NERPM Version 1.2

Summary of Changes

Appendix A

CR 16A and Johns Island Parkway subarea network and TAZ updates

Braddock Zone (Not Coded- Requires Approval/ TAZ Split)

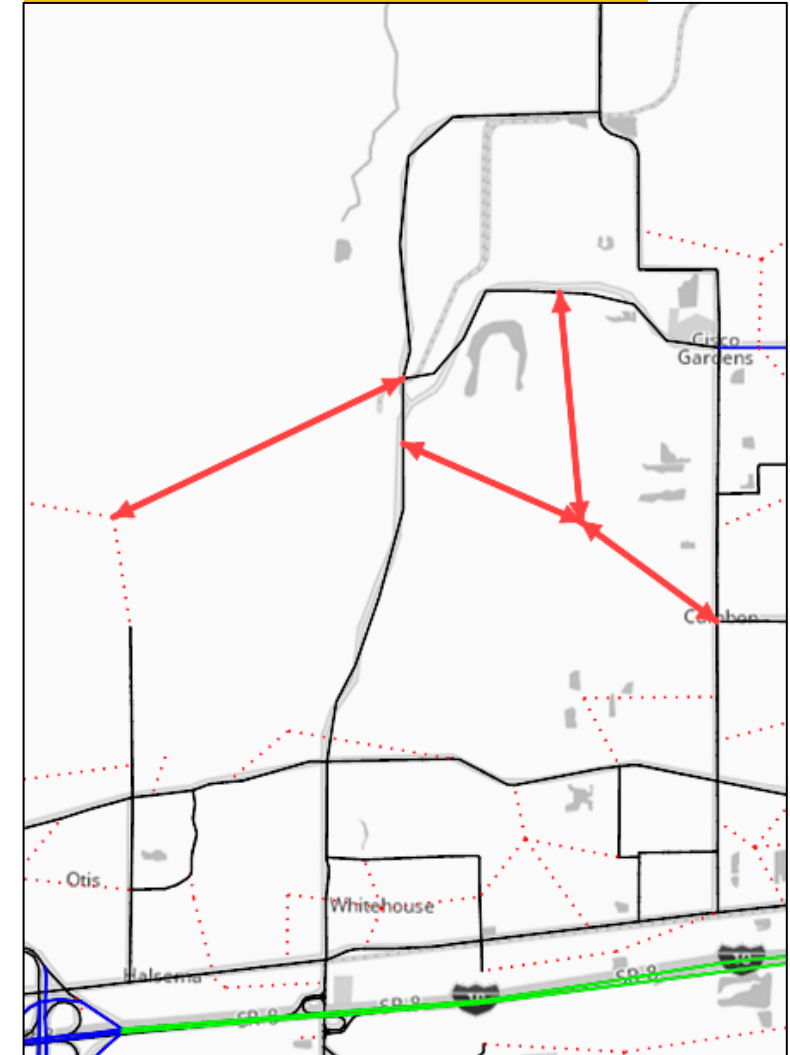
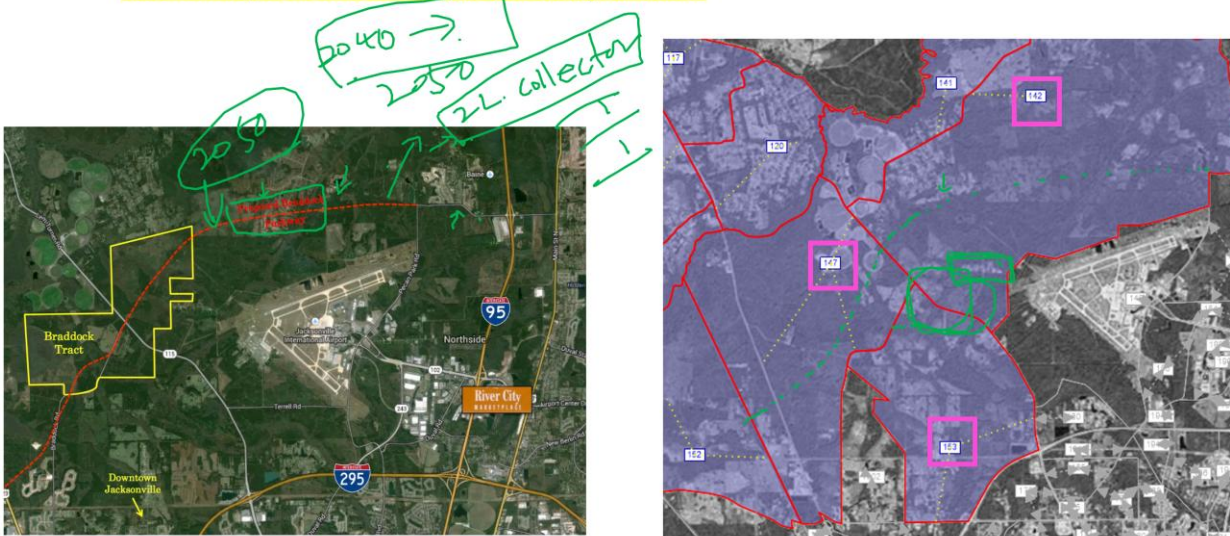
- Add the Braddock Zone area roadway as a 2-lane link in the 2040 and 2050 model networks.
- **Area Type: 33 (Transitioning Areas/Urban Areas over 5,000 Population)**
- **Facility Type: 46 (Other Local Undivided Roadway without Turn Bays)**
- Add connectors to integrate the new roadway into the network.

- Comment: Based on the available information, a new Braddock Tract development is located within the yellow highlighted area, which is across **Zone 142**, **Zone 147**, and **Zone 153**.
- Question: Is there a specific location or source that identifies the zone split boundary?
- Action Item: Split the zone in base-year and future-year models.

Pecan Park Zone (Not Coded- Requires Approval/ TAZ Split)

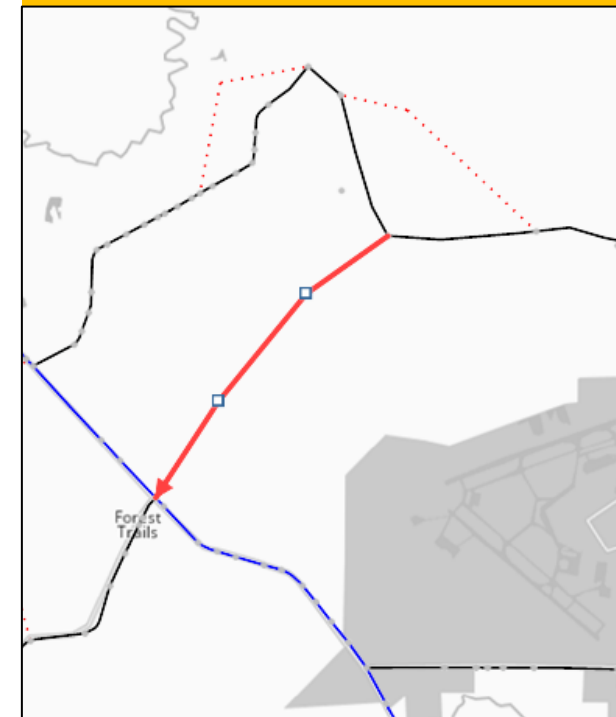
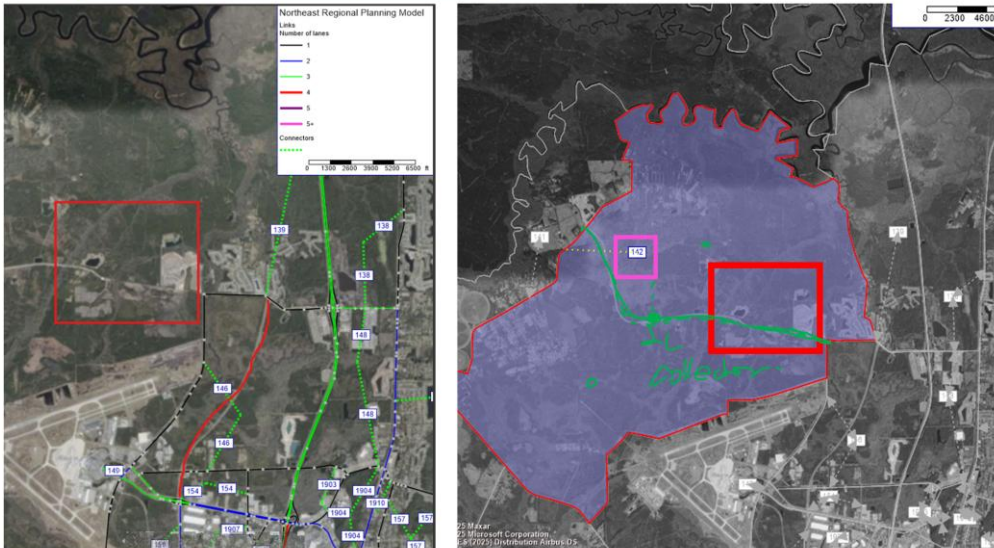
- Add the Pecan Park Zone roadway as a 2-lane link in the 2020, 2030, 2040, and 2050 model networks.
- **Area Type: 33 (Transitioning Areas/Urban Areas over 5,000 Population)**
- **Facility Type: 46 (Other Local Undivided Roadway without Turn Bays)**
- Add connectors to integrate the new roadway into the network.

- Comment: No online information was found that corresponds to the red highlighted area.
- Question: Since the red highlighted area is entirely within **Zone 142**, should it still be split into a separate zone?
- Action Item: Split the zone in base-year and future-year models.

Estuary Zone (Not Coded- Requires Approval/ TAZ Split)

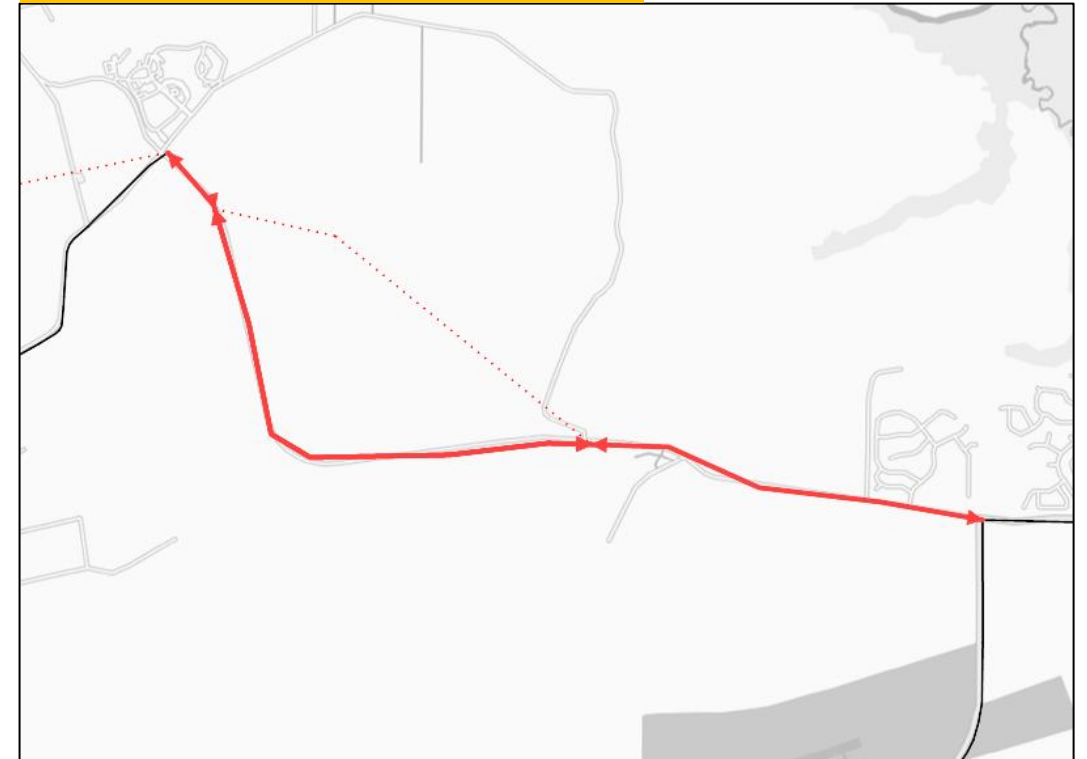
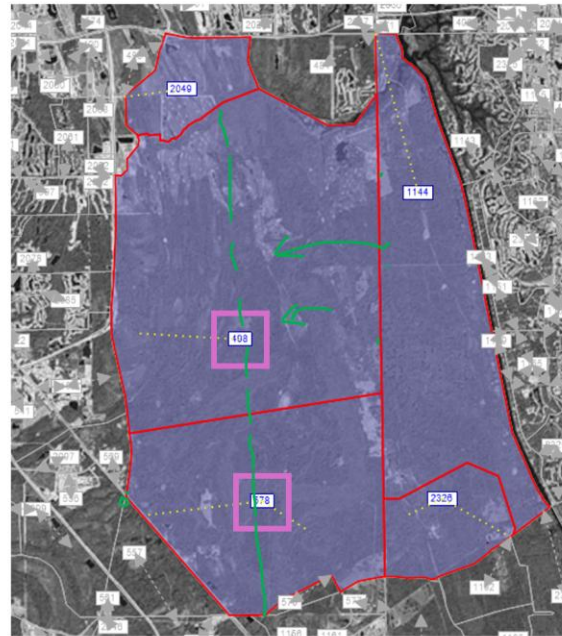
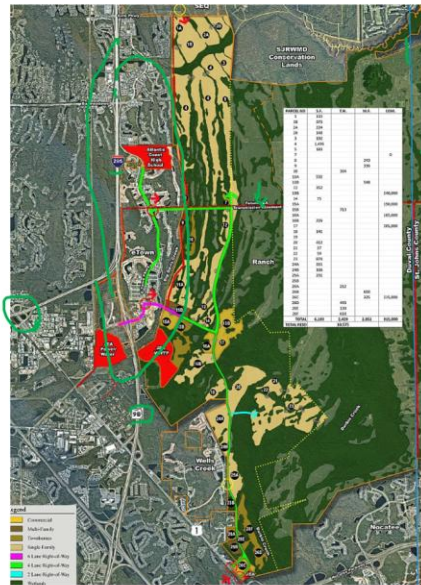
- No network update

- Comment: Based on the available information, there is a development across **Zone 408** and **Zone 578**.
- Question: Is there a specific location or source that identifies the zone split boundary?
- Action Item: Split the zone in base-year and future-year models.
